# United States Patent and Trademark Office

APPLICATION NO.	FI	LING DATE	FIRST NAMED INVENTOR	ATTORNEY DOCKET NO.	ATTORNEY DOCKET NO. CONFIRMATION NO.	
10/675,288	C	9/30/2003	William Joseph Jacob	. 5436		
	7590	07/26/2006		EXAMINER		
William Jose			LOPEZ, AMADEUS SEBASTIAN			
10904 Indiana Avenue Kansas City, MO 64137				ART UNIT	PAPER NUMBER	
,				3743		
			DATE MAILED: 07/26/2006

#### **DETAILED ACTION**

FIG. 2

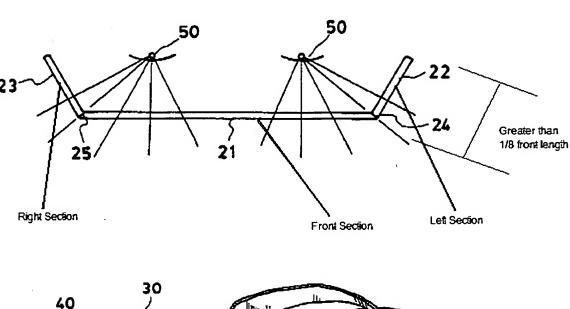
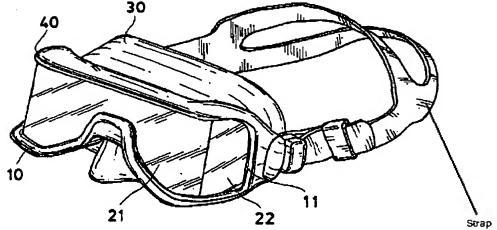
face from externalities, said goggle comprising: a lens (20) having transparent front, left and right sections (labeled in figure below), wherein said front section defines a lateral front length, and said left and right sections each extends transversely from the front section and presents a length not less than one-eighth of the lateral front length; a liner (30) attached to the lens, and configured to form a seal between the lens and the wearer's face, when the goggle is donned (although not explicitly stated by Chen-Lieh, it is inherent that skirt 30 forms a seal between the lens and the wearer's face because that is how goggles function; a seal is formed around the periphery of the mask so that water may not enter the goggles); and a securing element (straps labeled in Fig. 2 below) for securing the lens in a fixed position relative to the wearer's face, and compressing the liner, so as to form an airtight chamber between the lens and the portion of the wearer's face, when the goggle is donned. What is not taught by Chen-Lieh, but is taught by Hunter is that the lens is flexible (Col. 3, lines 33-35). Therefore it would have been obvious to one of ordinary skill in the art at the time the invention was made to modify the lens of Chen-Lieh to be flexible because it is well known in the art as taught by Hunter to make the lenses flexible to perhaps be able to make the lenses removable for cleaning or replacement. Further, Chen-Lieh does not explicitly state that the liner (30) is compressible. What is taught by Liu are goggles in which the liner (102) is compressible (Col. 1, line 66 to Col. 2, line 7; states that peripheral edge 102 is resilient which means it is capable of being compressed). Therefore it would have been obvious to one of ordinary skill in the art at the time the invention was made to modify the goggles of Chen-Lieh to utilize a compressible liner as taught by Liu for creating a

"watertight engagement with the facial skin of the user in a region around the eyes and nose (Col. 2, lines 1-2)..." so that water does not enter the chamber formed between the goggles and the face of the user.

- 7. With regards to claim 5, what is taught and shown by Chen-Lieh in Fig. 2 shown above are securing elements including at least one adjustable strap removable coupled to the lens (as shown in Fig. 2, straps are removable if pulled through the stirrups).
- 8. With regards to claim 6, what is taught and shown by Chen-Lieh in Figs 1-5 is a goggle with all the limitations of claim 6 with the exception of wherein said at least one strap comprises stretchable material. What is taught and shown by Hunter in Fig. 2 is a goggle wherein said at least one strap (19) is comprised of a stretchable material (Col. 3, lines 44-46; states that headband is elastic). Therefore it would have been obvious to one of ordinary skill in the art at the time the invention was made to modify the straps of the goggle taught by Chen-Lieh to be comprised of a stretchable material as taught by

- 9. With regards to claim 7, what is taught and shown by Chen-Lieh in Fig. 2 is a goggle wherein the securing element includes an adjustable fastener operable to fix the strap in one of a plurality of positions. As shown in Fig. 2 above, the strap can either be pulled taut about the stirrup to decrease the diameter of the goggle head size, or loosened about the stirrup to increase the diameter of the diameter of the goggle head size.

- 11. Claim 8 is rejected under 35 U.S.C. 103(a) as being unpatentable over Chen-Lieh/Hunter/Liu in further view of US Patent No. 5421037 to Schulze.
- 12. With regards to claim 8, what is taught and shown by Chen-Lieh in Fig. 2 is a goggle wherein said securing element includes a strap and stirrup configuration. What is not taught by Chen-Lieh but is taught by Schulze in Figs. 1-3 is said fastener including a loop (18) and hook patch (VELCRO hook fastener strips 34 and 36), said loop patch being operable to receive and hold the hook patch (Col. 2, lines 49-68). Therefore it would have been obvious to one of ordinary skill in the art at the time the invention was made to modify the goggle of Chen-Lieh to utilize a hook and loop type fastener to secure straps of the goggles against the head of the user because it is well known in the art and has proven effective as taught by Schulze to secure goggles to the

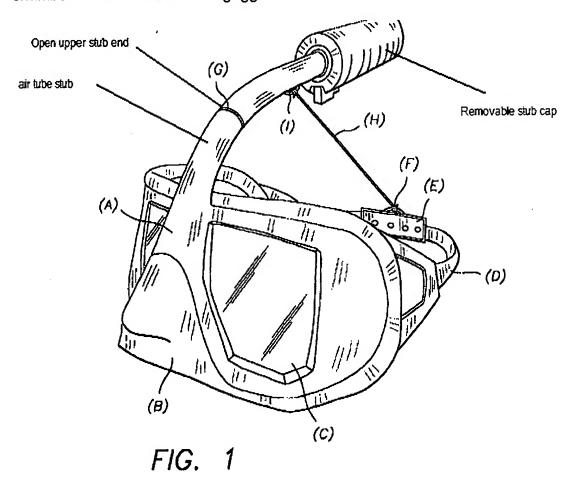
16. With regards to claim 10, what is taught and shown by Chen-Lieh/Hunter/Liu is a goggle with all the limitations of claim 10 with the exception of said liner (30) being fluorescent. What is taught by Gasbarro is a diver's safety cap in which it is taught that the outer shell of the helmet may have fluorescent paint or tape applied to it so that others may be able to identify and visually locate the user of the helmet. Therefore it would have been obvious to one of ordinary skill in the art at the time the invention was made to apply fluorescent coloring to the goggles taught by Chen-Lieh/Hunter/Liu because it is well known in the art to apply fluorescent tape or paint to the apparel of scuba divers so that they may be visually located by others underwater where it is known to be very dark.
